ADDENDUM NO. 1

CAESARS LANE
WASTEWATER TREATMENT PLANT EXPANSION
PHASE 2 PROJECT

TOWN OF NEW WINDSOR
ORANGE COUNTY, NEW YORK

DATE: June 6, 2025
JOB #: 18-732

ELECTRICAL DEMOLITION SINGLE LINE DIAGRAM - MCC 4

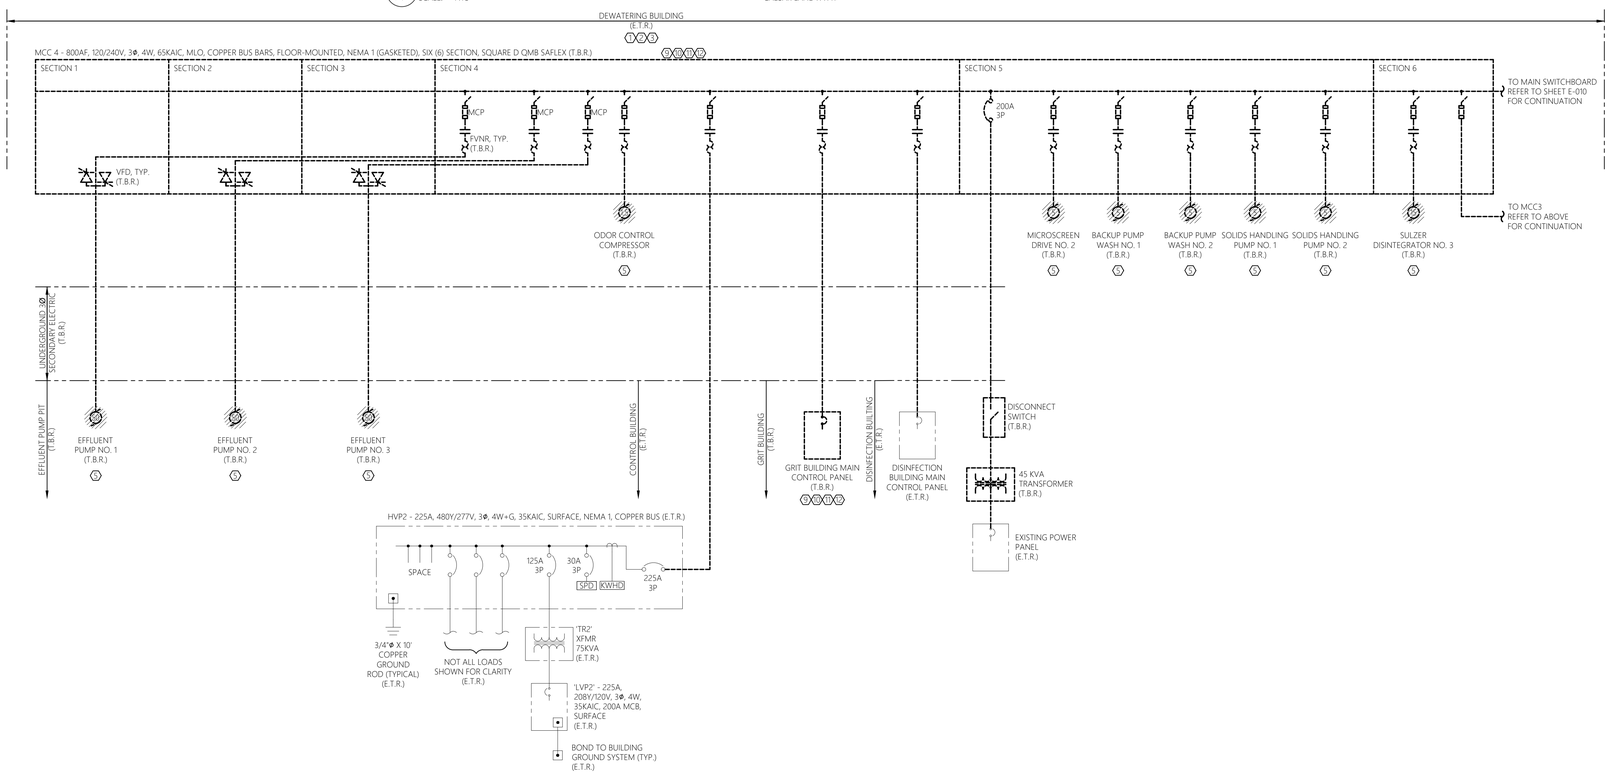
- Upsize panel "LVP1" and transformer "TR1".
     - Added transformer "TR8" to feed existing panelboard "PP-1".
   - Altered MCC 4 Demolition Single Line Diagram to illustrate demolition of existing feeder to Disinfection Building.

1 E-020 MBR CONTROL PANEL RISER DIAGRAM
SCALE: NTS

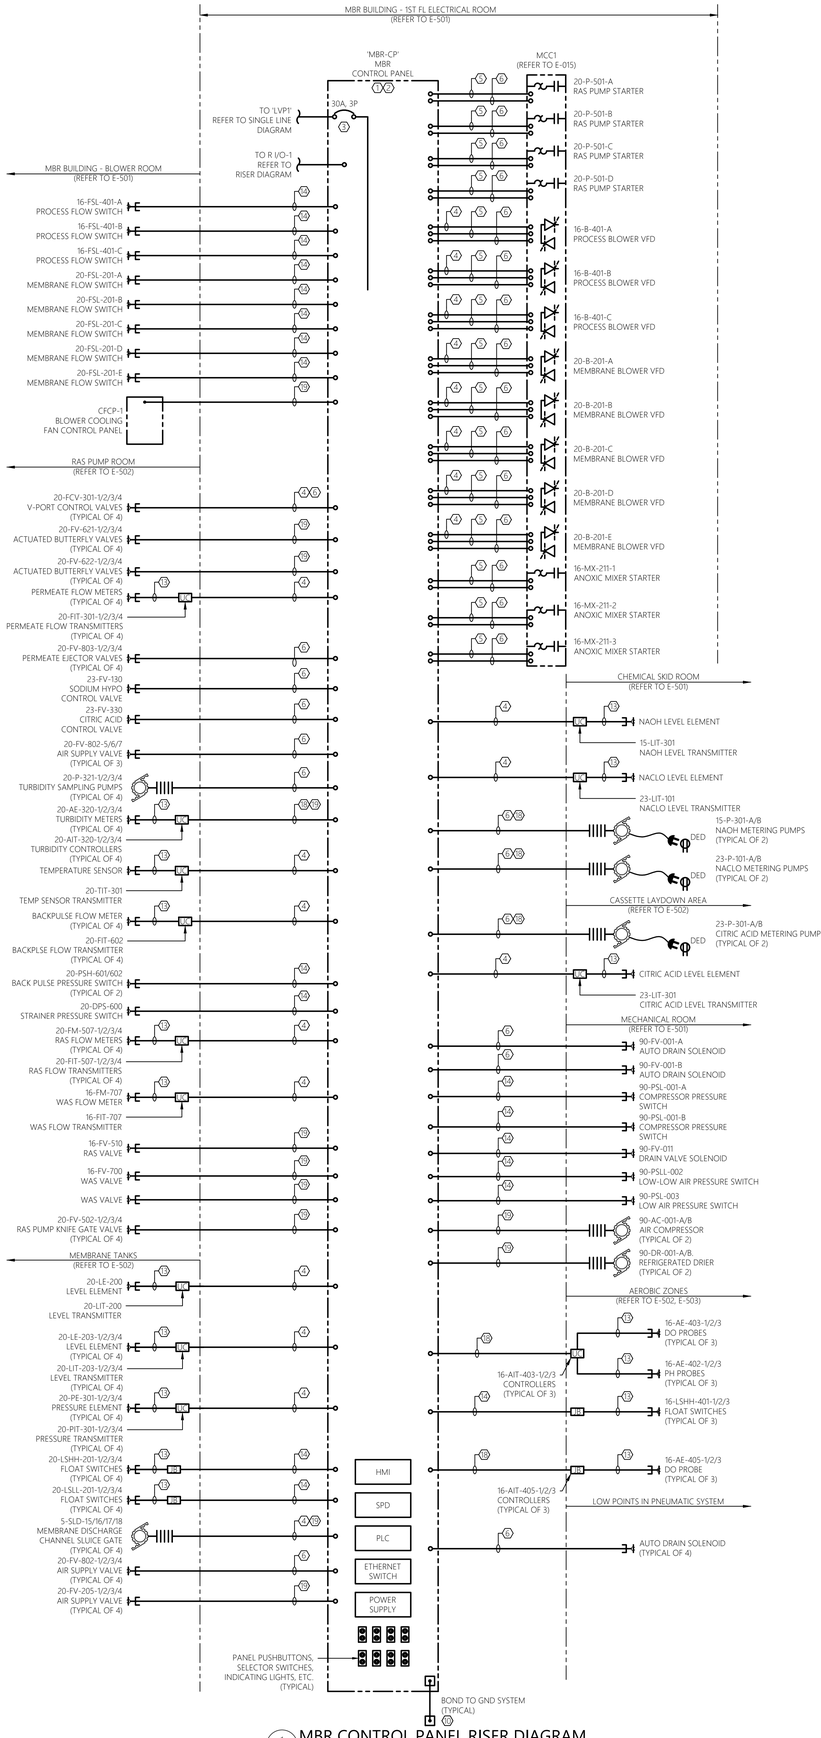
- Revised Riser Diagrams to reflect BOD process equipment (instrumentation, circuitry sizes, conductor quantities). Significant changes were made to the following Riser Diagrams:

- MBR Control Panel.
     - ATAD Control Panel.
     - Existing Disinfection Building SCADA Panel.
   - Updated all schedules to coordinate with the drawing set.

1 S-220 EXISTING GRIT CHAMBER AND SPLITTER BOX MODIFICATION PLAN
SCALE: 3/8" = 1'-0"

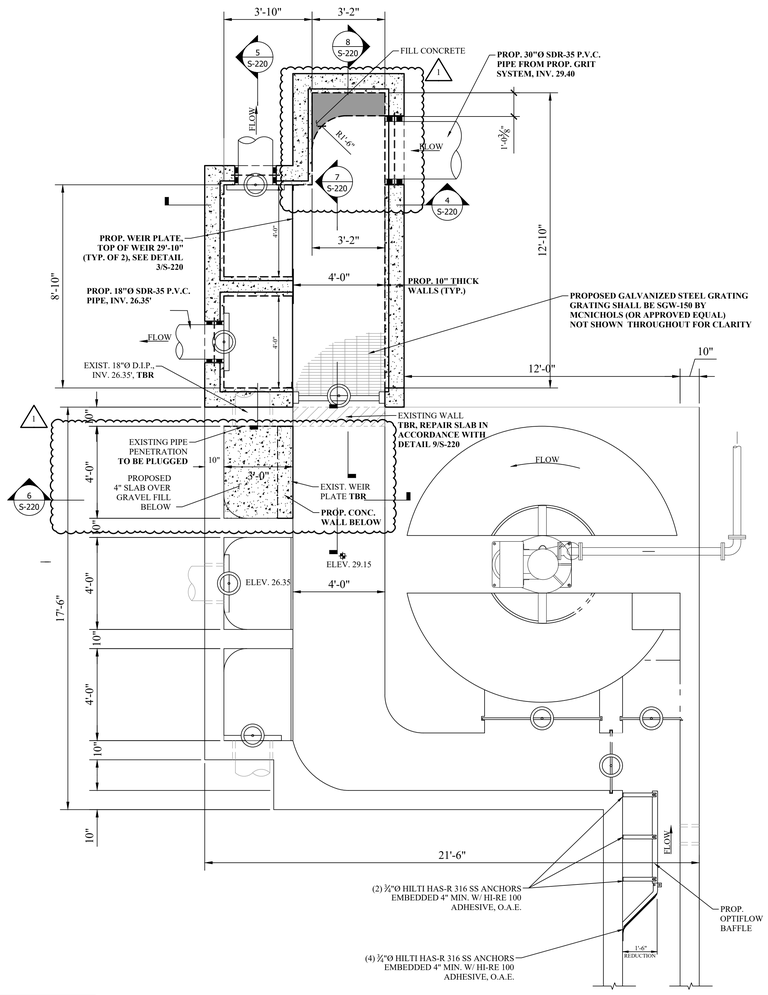
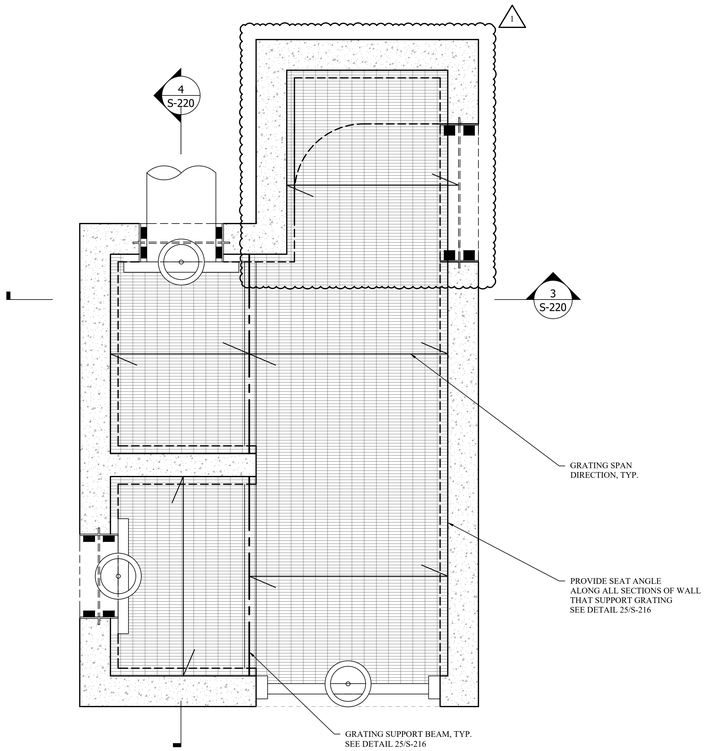
2. Plan sheet S-220 “Existing Grit Chamber and Distribution Box Modification Plan and Details” revised plan dimensions of proposed distribution box and added gravel fill and slab over portion of existing distribution box. Revised Plan Sheet S-220 is attached.

1 S-520 MBR BASIN FOUNDATION PLAN
SCALE: 1/4" = 1'-0"

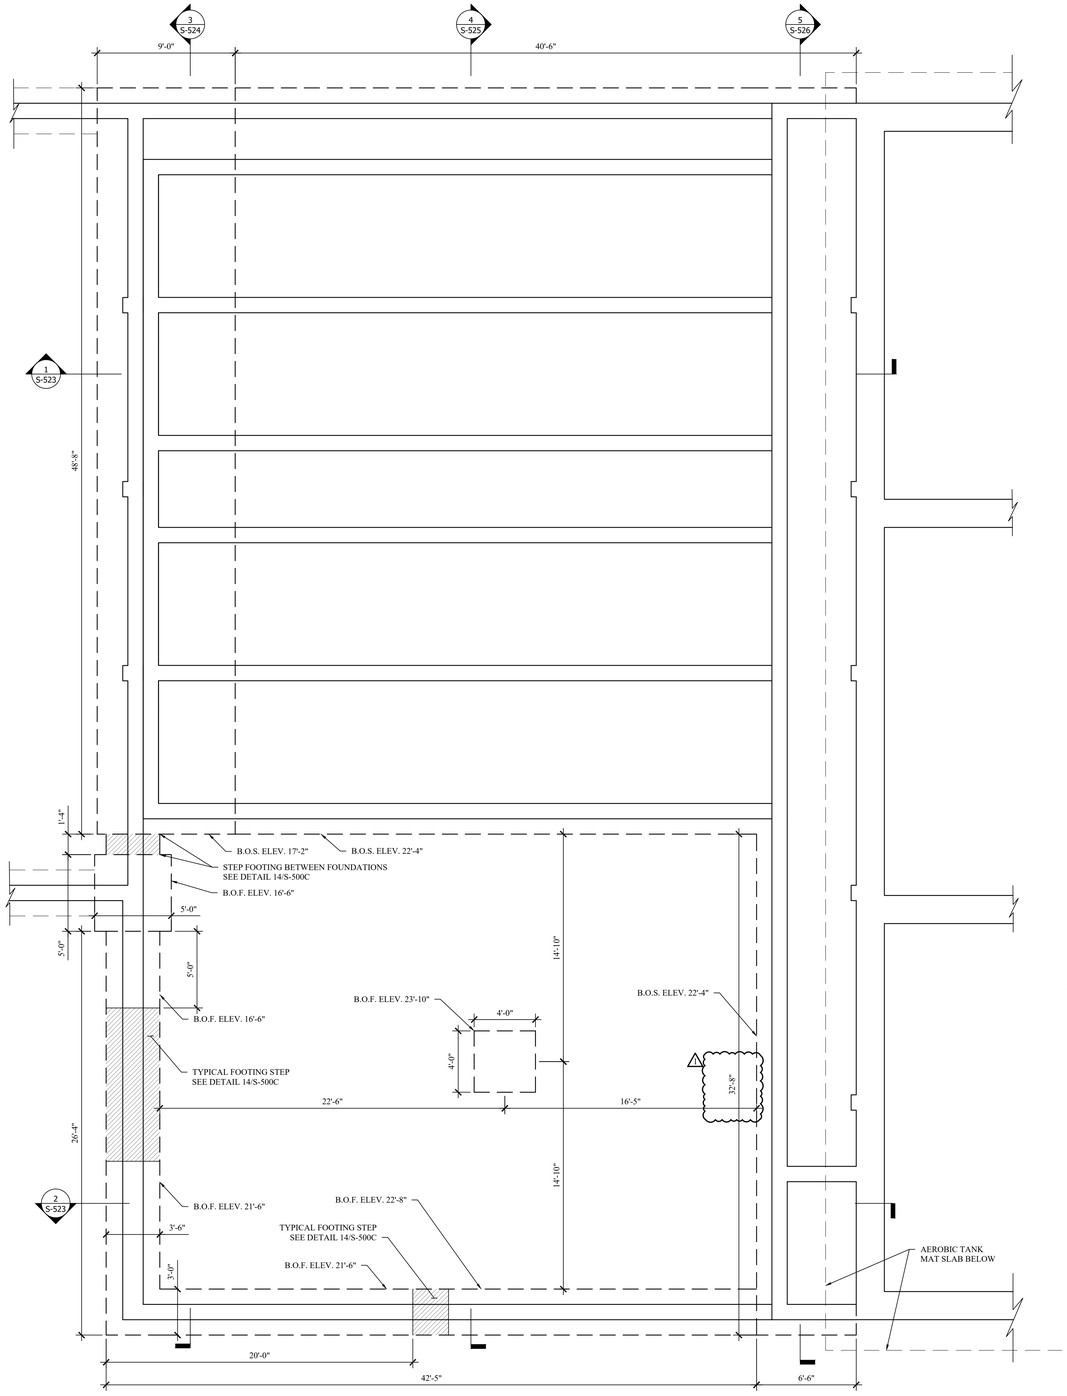
3. Plan sheet S-520 “MBR Basin Plans” revised dimension on MBR Basin Foundation Plan. Revised Plan sheet S-520 is attached.
4. Plan sheet S-620 “Chlorination/Dechlorination Tank Blower Platform Plans” revised framing and dimensions of blower platform. Revised Plan Sheet S-620 is attached.

1 S-621 BLOWER PLATFORM SECTION 1
SCALE: 1/2" = 1'-0"

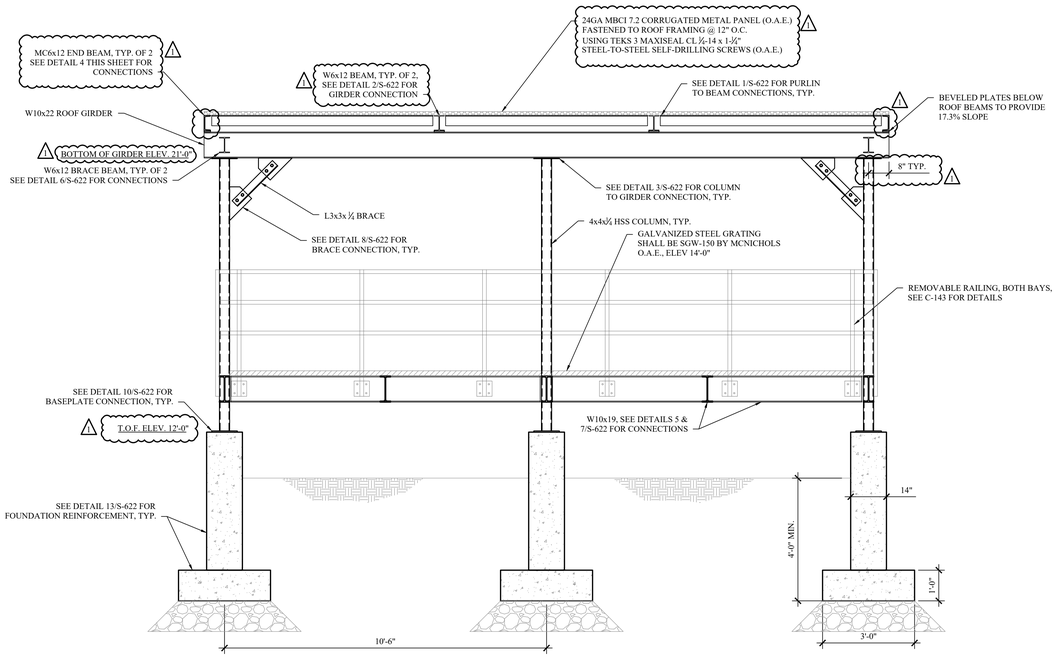
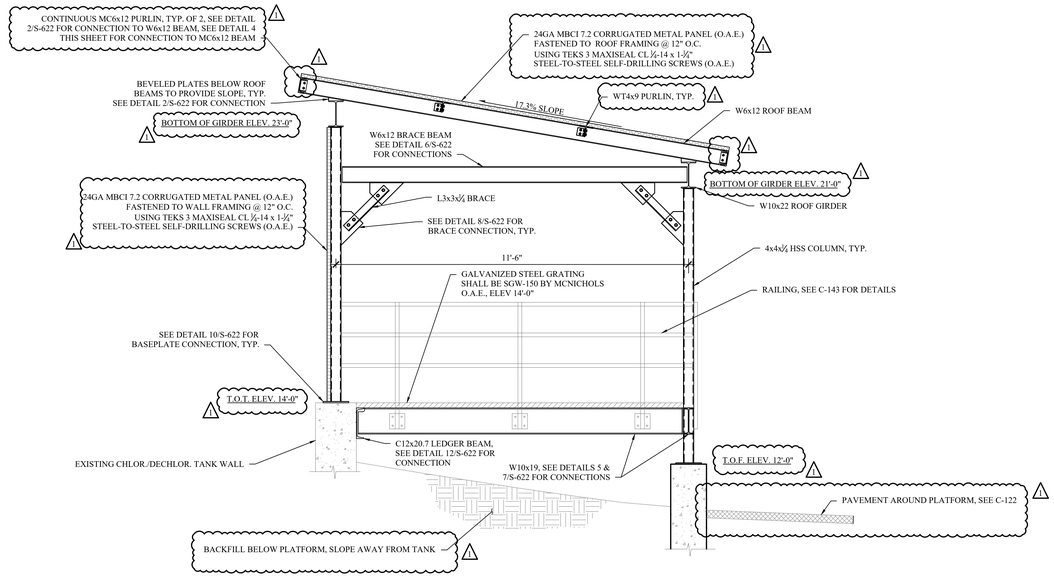
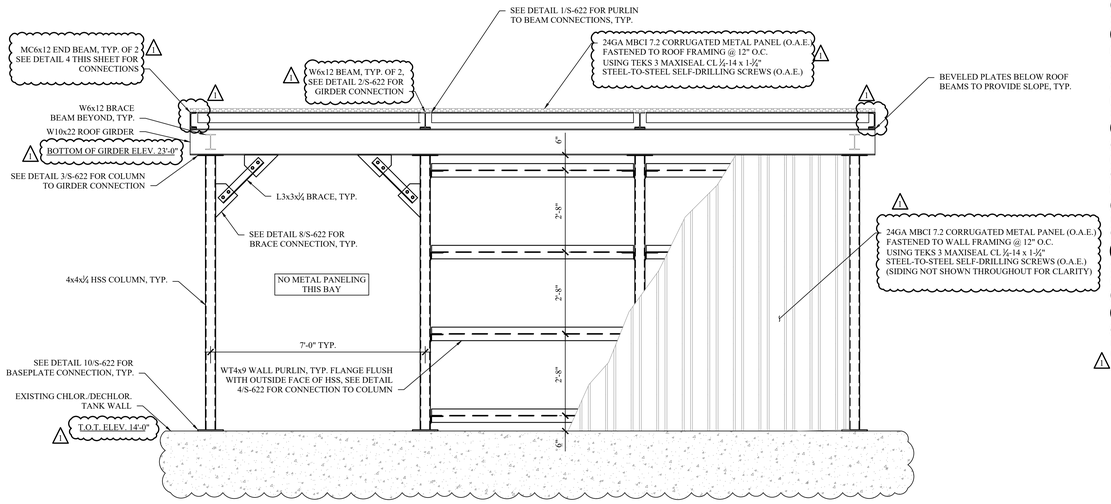
5. Plan sheet S-621 “Chlorination/Dechlorination Tank Blower Platform Sections” revised framing and dimensions of blower platform, added elevation, grade and pavement information. Revised Plan sheet S-621 is attached.
